Site Control Modification Manual 14H Update

Markets and Reliability Committee February 20, 2025

Manual 14H – Section 4.9.2

Exhibit 10: Generator Interconnection into Existing TO Substation

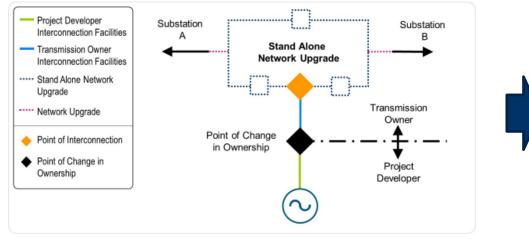
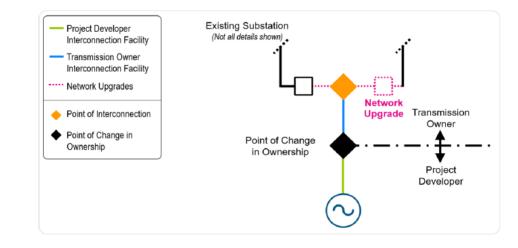
- In M-14H Section 4.9 shows diagrams of typical New Service Request Connection Types
- Exhibit 9 shows "Generator Interconnection via New Interconnection Switchyard"
- Exhibit 10 is supposed to show "Generator Interconnection into Existing TO Substation" but instead is the same diagram used in Exhibit 9

- PJM seeks to correct Exhibit 10
- PJM seeks to provide greater clarification on how Developers can meet tariff requirements for Site Control and what Site modifications are allowed under the tariff
- As PJM continues progress through TC1 and TC2 applications are due in Q4 2024, it is important for Developers to understand what Site Control modifications are allowed under the tariff in order to be able to continue to develop their projects and meet tariff requirements for Site Control at various points of the Interconnection Cycle process

Exhibit 10: Generator Interconnection into Existing TO Substation
